PLANNING COMMISSION  
DATE: 9/22/13  
AGENDA ITEM: 4A – BUSINESS ITEM  
CASE # 2014-44

ITEM: Hammes Estates Residential Subdivision – Final Plat (Phase 1)

SUBMITTED BY: Nick M. Johnson, City Planner

# PARK LOCATION PLAN

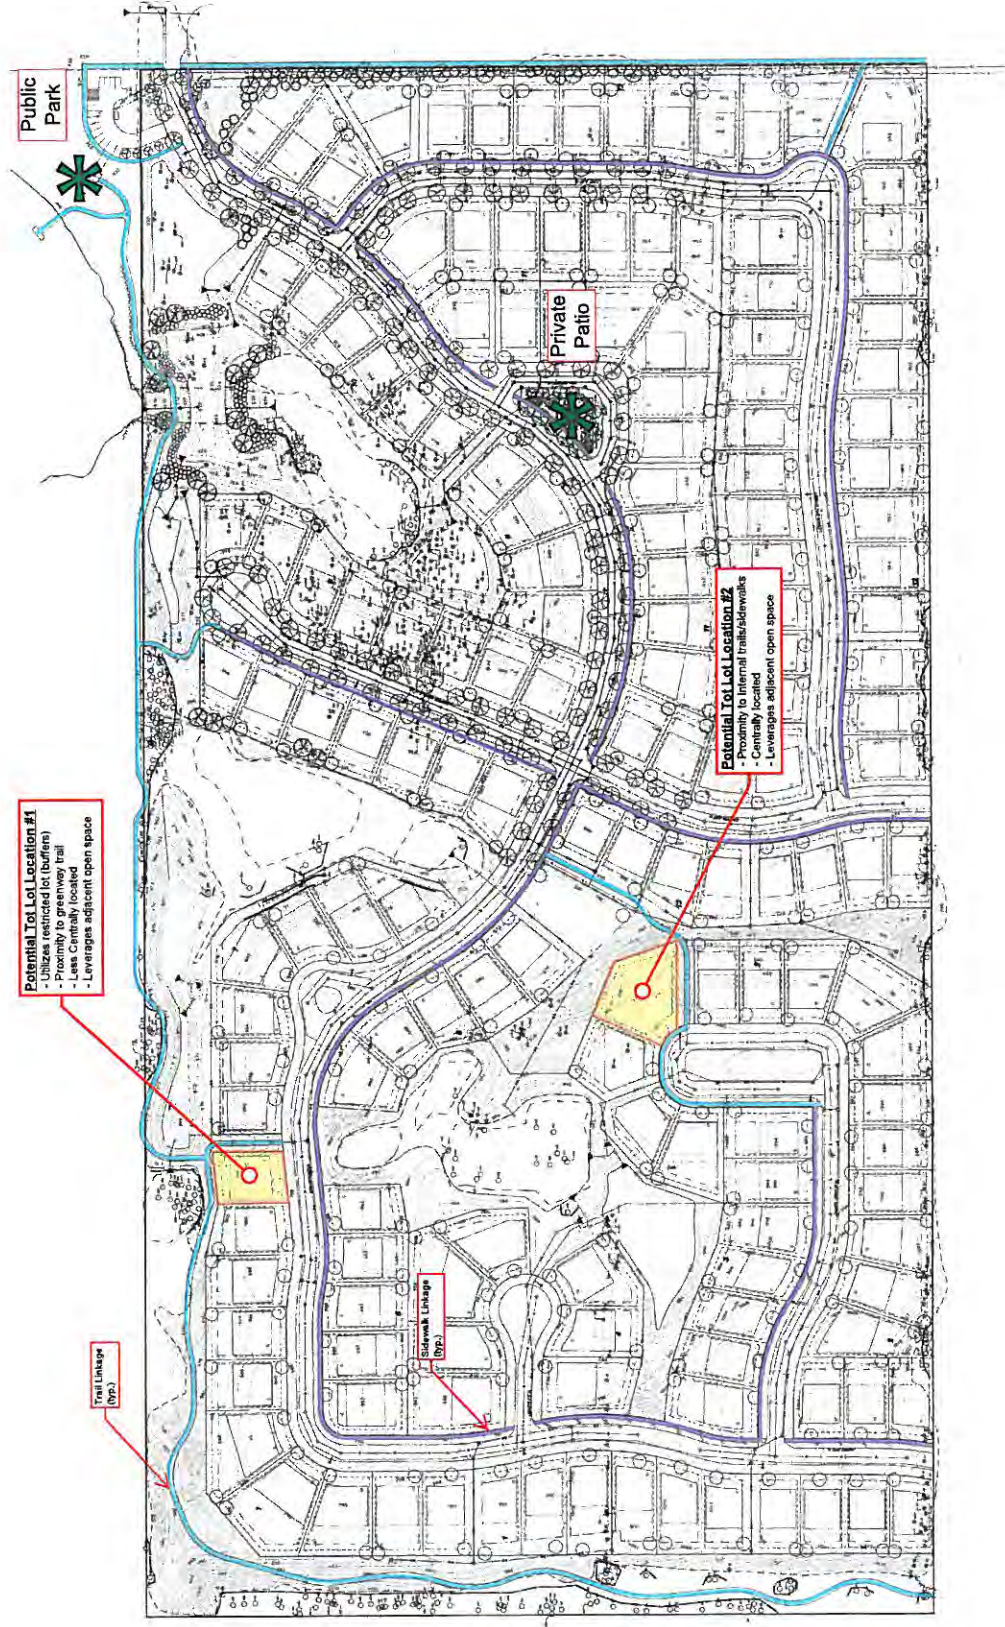
*Regarding the design of Goose Lake Park, the applicants have submitted additional details of the proposed park area as part of the Final Landscape Plan. The proposed grading addresses staff concerns regarding the location of the improvements in the context of the 100-year flood elevation of Goose Lake. However, the park property improvements must be revised to better separate the public use area and the lift station utility area. The City Engineer has provided a proposed sketch (Attachment #14) that reorients the parking to better separate these areas, allowing for better access and work space for City maintenance*

*staff. As a condition of approval, the park property improvements must be revised to meet the approval of the City Engineer. This design must also maintain the required 25-foot setback from the OHWL as specified in the Valley Branch Watershed District Permit. Finally, the applicant will be required to obtain the necessary watershed district permit for the improvements to Goose Lake Park (Condition #12).*

- 11) The applicant shall abide by all conditions of the MN DNR Public Waters Work Permit dated 8/27/14.
- 12) The applicant must revise the Goose Lake Park Plan to provide greater separation between the public use area and the lift station maintenance area. The applicant will be responsible for all necessary watershed district permitting requirements related to the Goose Lake Park improvements.
- 13) Per the recommendation of the Fire Chief, the applicant must submit all documentation related to the mitigation of the soil contamination to the Minnesota Pollution Control Agency's Voluntary Brownfield Program for review and approval.
- 14) Prior to the acceptance of the public improvements for the 1<sup>st</sup> Phase of the Hammes Estates subdivision, all wetland buffers shall be delineated and identified via staking or signage that is acceptable to the City.
